APPLICATION NO.	FILING DATE	FIRST NAMED INVENTOR	ATTORNEY DOCKET NO.	CONFIRMATION NO.
10/693,005	10/24/2003	John W. Forsberg	1023-294US01	9349

Office Action Summary

DETAILED ACTION

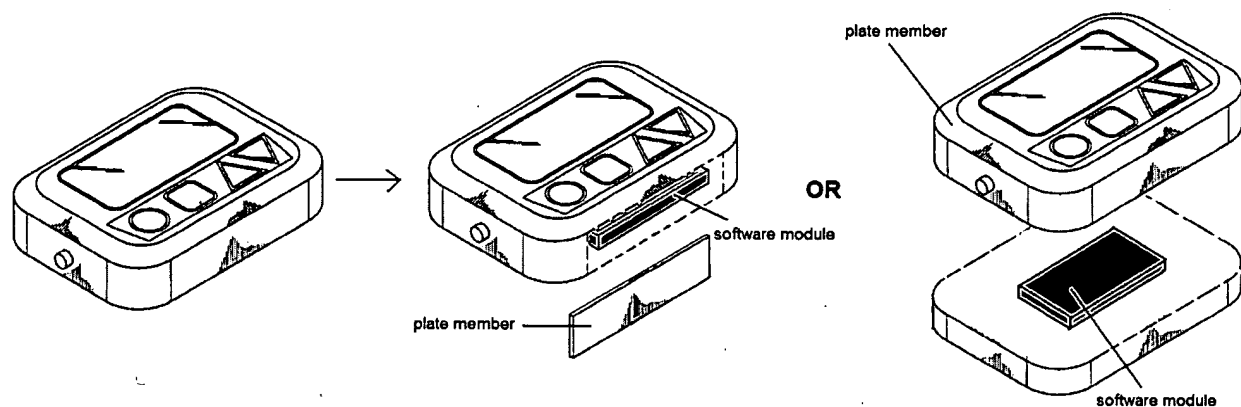
Regarding claims 6 and 8, the device of Meadows et al. is shown in Fig. 5 to be constructed of a housing with more than one part (Fig. 5, column 36, line 46 discloses an upper housing). Any electronic device comprising housing of more than one part and containing software loaded on a memory inherently comprises a software loading port, where the port is considered to be the open portion of the housing in which the software-loaded circuitry is being inserted or affixed, and the other portion of the housing is considered to be the plate member covering the loading port.

Regarding claim 9, Meadows et al. discloses that the plate member be printed with identifying information (column 38, line 55 through column 39, line 15). Given the configuration shown on the right side of the figure above, the disclosed labels on the buttons clearly satisfy this claim limitation.

Furthermore, having a battery bay that extends into an aperture defined by the antenna is almost inherent in the nature of a device small enough to be held in the hand (the figure provided above with a battery in place of the memory module provides a good example of this). Still further, the aperture as claimed could be defined as the housing of HHP 202, of which the battery bay is an inherently integral and internal part.
